SUBJECT: PLANS AND PROPOSAL ADDENDUMS

PROJECT: F 2023(060)

CONTROL: 0089-10-026

COUNTY: WHARTON

Texas Department of Transportation		Bridge Division	
<b>RAIL RETROFIT DETAILS</b>			
<b>SH 60 AT PEACH CREEK BRIDGE</b>			
FILE: SH060_BRG_RL497mi01.dgn	DN: CG	CK: HTP	DW: SFS
REVISIONS	CONT	SECT	JOB
0089	10	026, ETC	SH 60, ETC
DIST	COUNTY	SHEET NO.	
YKM	WHARTON, ETC	66B

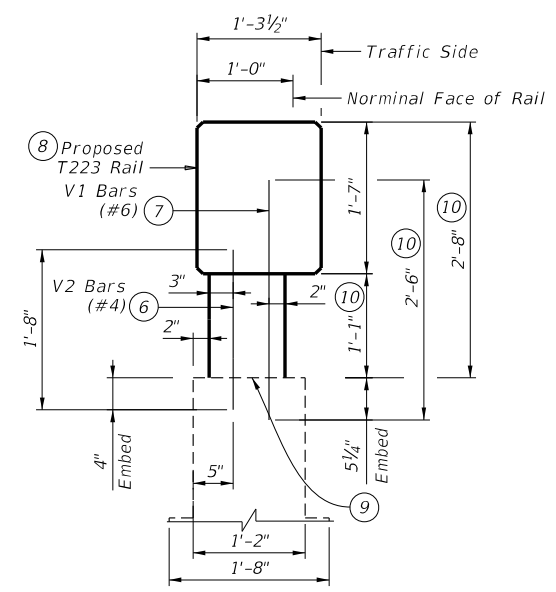
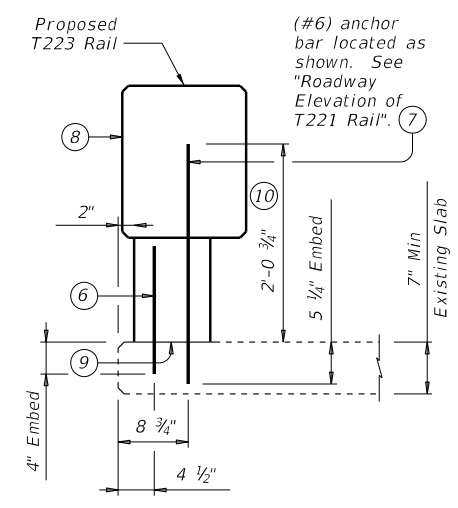
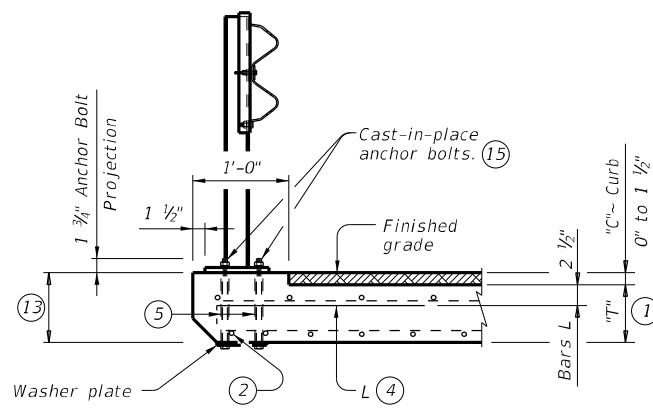
SHEET 66B (RAIL RETROFIT DETAILS) : ADDED TO PLANS TO CLARIFY CONSTRUCTION  
DETAILS

<b>Bridge Division Standard</b>	
<b>BOX CULVERT MOUNTING DETAILS FOR TYPE T631LS &amp; T631 RAILS (CURBS 5' TALL AND LESS ONLY)</b>			
<b>T631-CM</b>			
FILE: r1sto040-20.dgn	DN: TxDOT	CK: TxDOT	DW: JTR
REVISIONS	COWT	SECT	JOB
0089	10	026, ETC	SH 60
DIST	COUNTY	SHEET NO.	
YKM	WHARTON	73A

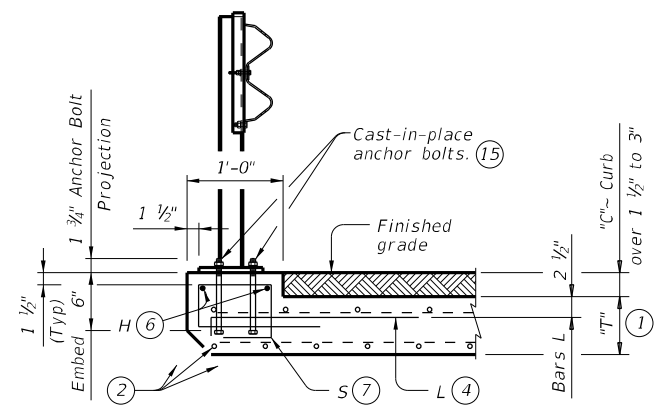
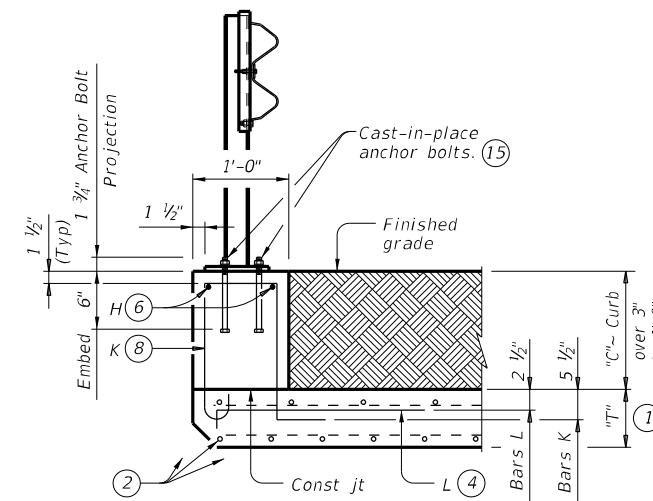
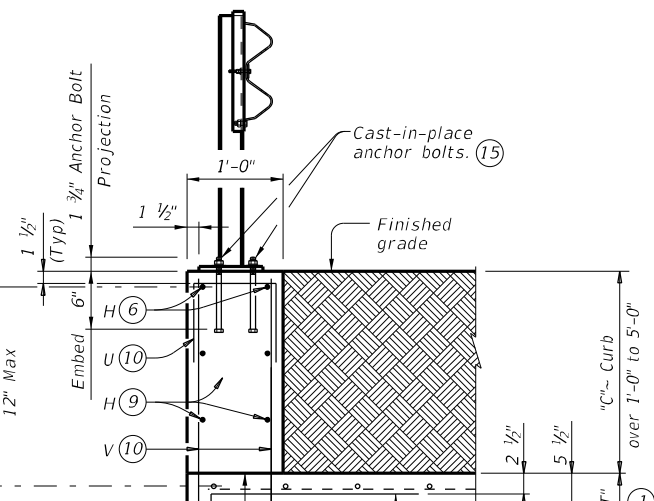
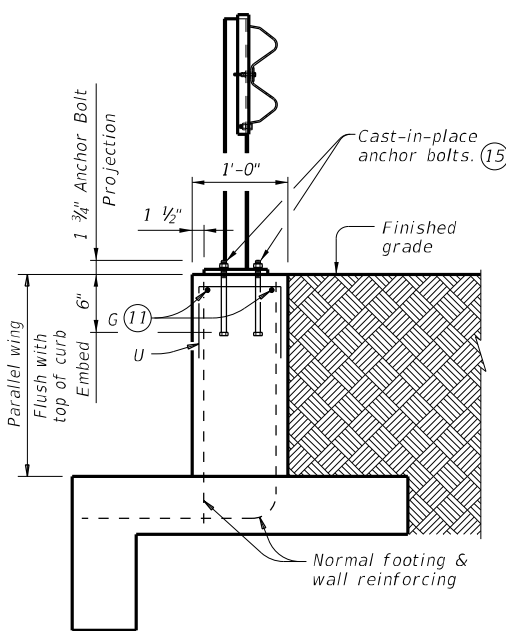
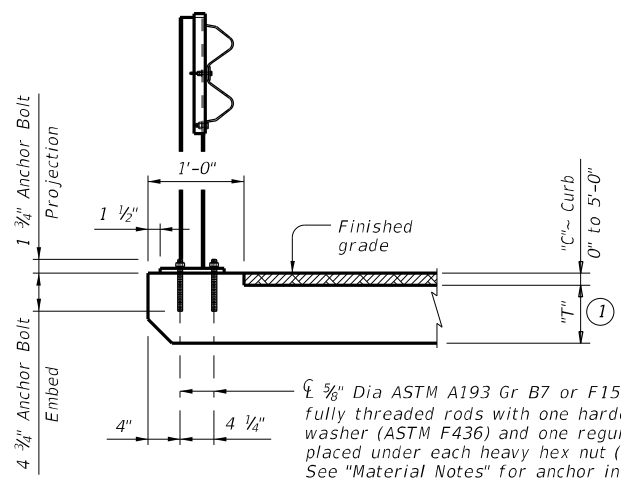
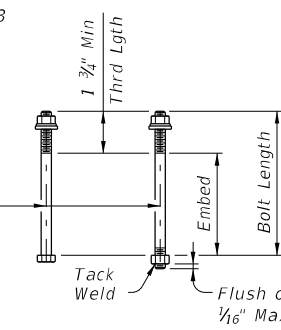
SHEET 73A (T631-CM) : ADDED SHEET TO THE PLANS TO CLARIFY CONSTRUCTION  
DETAILS
